Suggested HV cable attachment (1)

Requirements

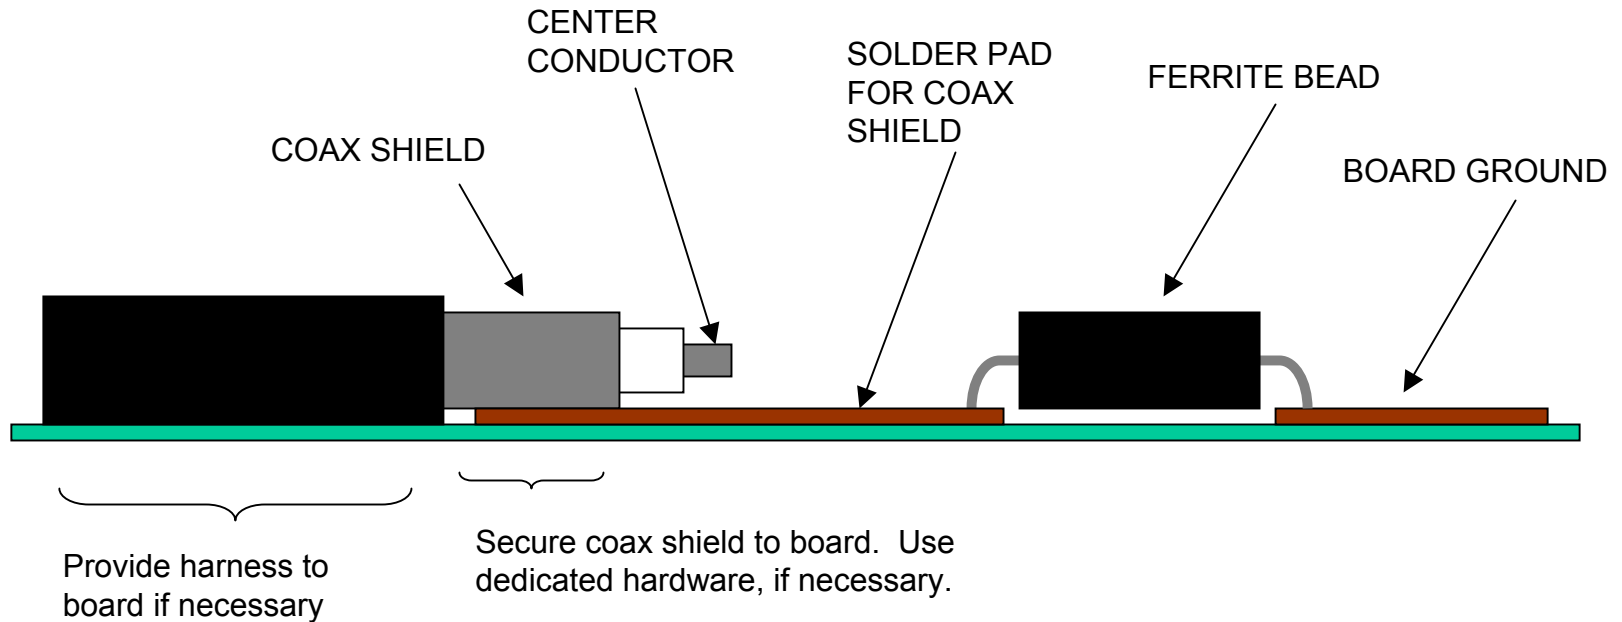
- No strain on the center conductor regardless of the presence of additional harness mechanism.
- The ferrite bead shall have its own footprint.

The cable can be either side-entry or bottom-entry to the PCB.

Portion of 5549B020 Rev F

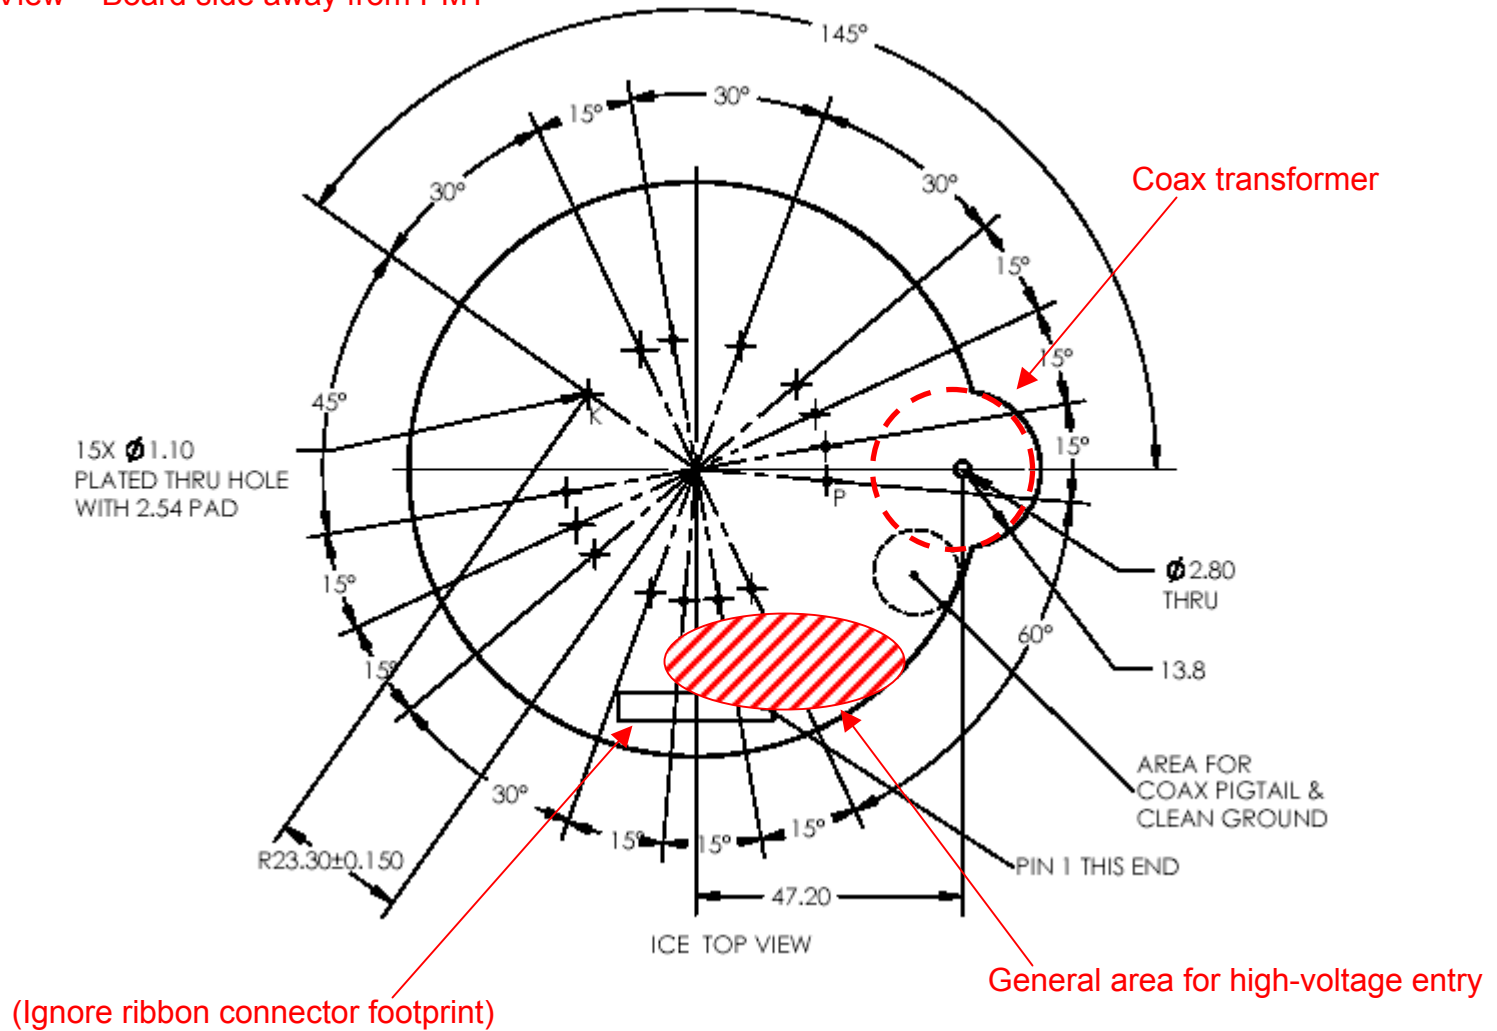
Note: Ignore Drawing Rev E (Incorrect PMT pin locations)
